DOCUMENT 2.3F

West Midlands Interchange	
Project THE WEST MIDLANDS RAIL FREIGHT INTERCHANGE ORDER 201X	
Drawing Status SUBMISSION	
Drawing Title ACCESS AND RIGHTS OF WAY PLAN SHEET 6 (INSET D AND E TO SHEET 1)	
Regulation 5 (2) (k)	Document 2.3F
Drawn NW Date: JUNE 2018 Scale 1: 1000	Reviewed JF
Drawing No. WSP-70001979-SK-060	Rev. E

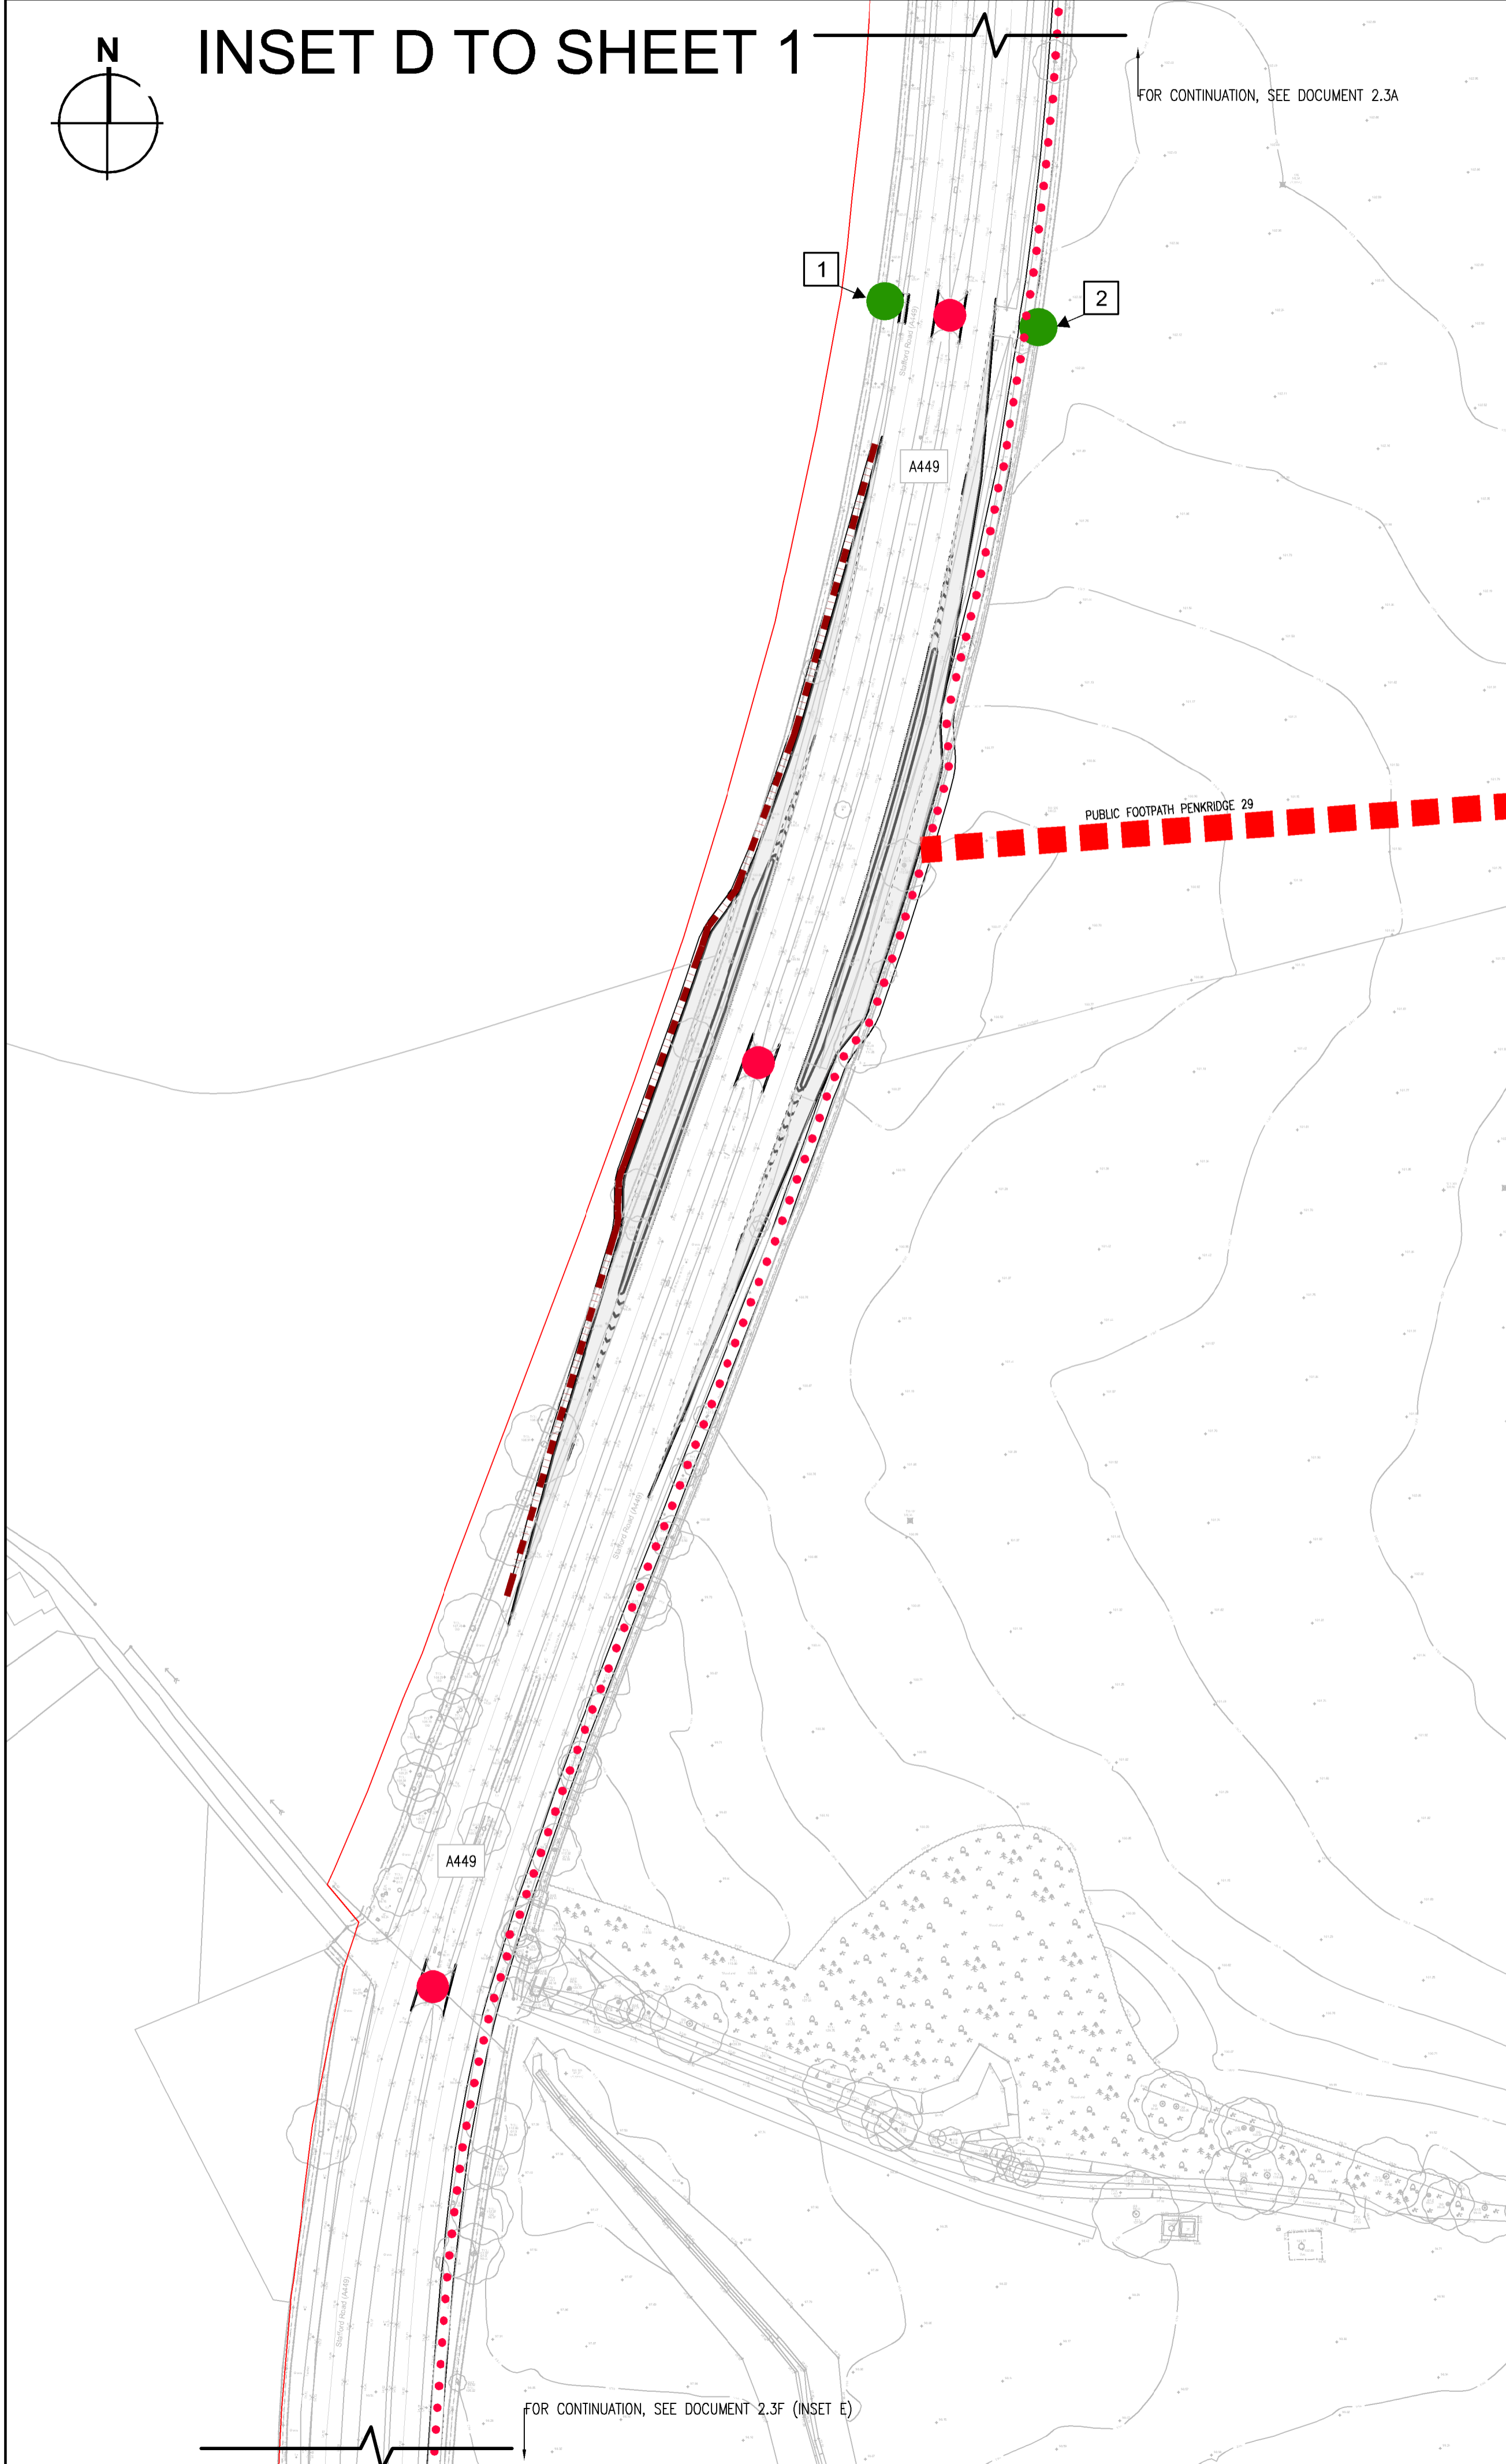
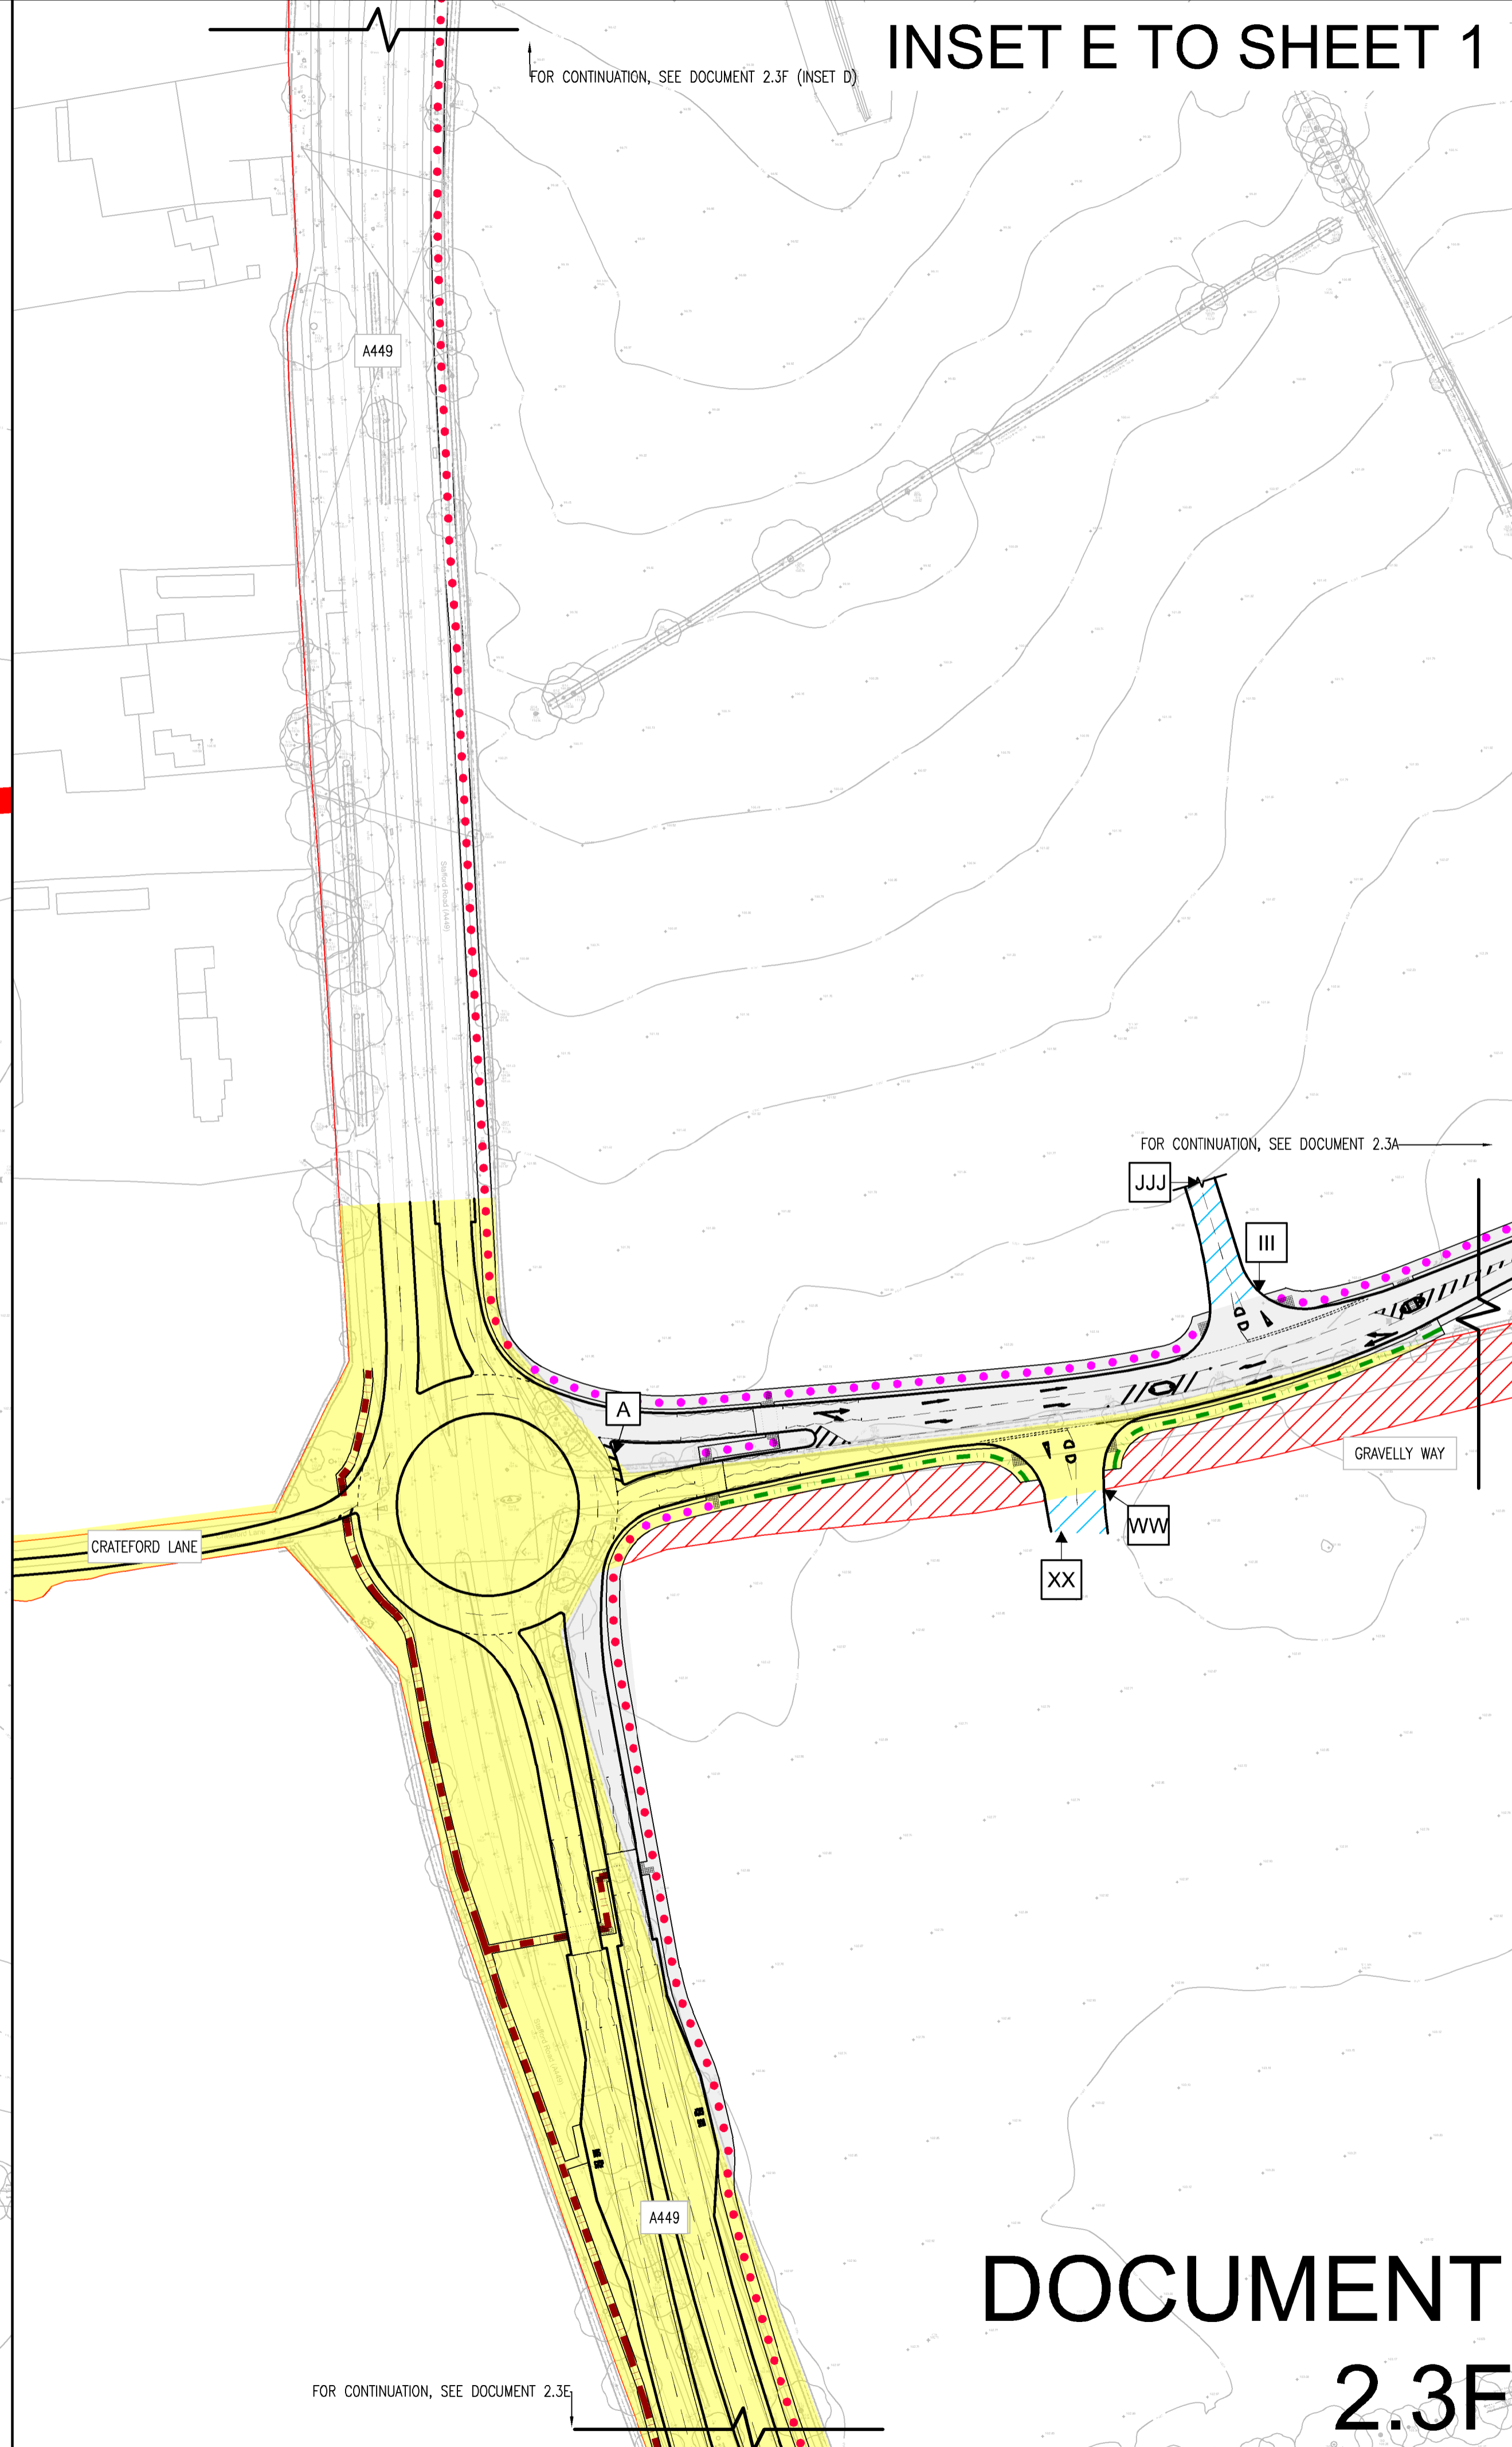
- CHANGES MADE TO DOCUMENT 2.3F SINCE DCO SUBMISSION:**
- MAY 2019 -
- PEDESTRIAN CROSSING ON THE A449 SIGNALISED AND RELOCATED FURTHER SOUTH OF THE ROUNDABOUT IN RESPONSE TO COMMENTS FROM HIGHWAYS ENGLAND IN RSA.

- PEDESTRIAN CROSSING ON GRAVELLY WAY MOVED EAST, STAGGERED AND SIGNALISED IN RESPONSE TO COMMENTS FROM HIGHWAYS ENGLAND IN RSA AND AS A RESULT, THE ACCESS TO THE RAIL TERMINAL HAS BEEN MOVED EAST. THE TOTAL WIDTH OF THE GRAVELLY WAY ARM HAS BEEN INCREASED TO PROVIDE SUFFICIENT WIDTH FOR THE CROSSING AND VEHICLE MOVEMENTS.

- FOOTWAY WEST OF THE A449 HAS BEEN RELOCATED AND RECLASSIFIED AS CYCLEWAY / FOOTWAY IN RESPONSE TO COMMENTS FROM HIGHWAYS ENGLAND IN RSA.
 - ADDITIONAL VERGE ON THE EASTERN SIDE OF THE A449 HAS BEEN ALLOCATED TO ENSURE VISIBILITY TO THE PEDESTRIAN CROSSINGS IS PROTECTED.

- JULY 2019 -
- LABELS REMOVED TO REFLECT SCC REQUEST THAT CERTAIN FOOTWAYS / CYCLEWAYS ARE NOT IDENTIFIED AS NEW PUBLIC RIGHTS OF WAY.
 - PEDESTRIAN CROSSING OF WESTBOUND GRAVELLY WAY POSITIONED FURTHER WEST IN RESPONSE TO HIGHWAYS ENGLAND COMMENTS AND RSA.

- CROSSING AREA ON CENTRAL ISLAND OF GRAVELLY WAY REVISED.
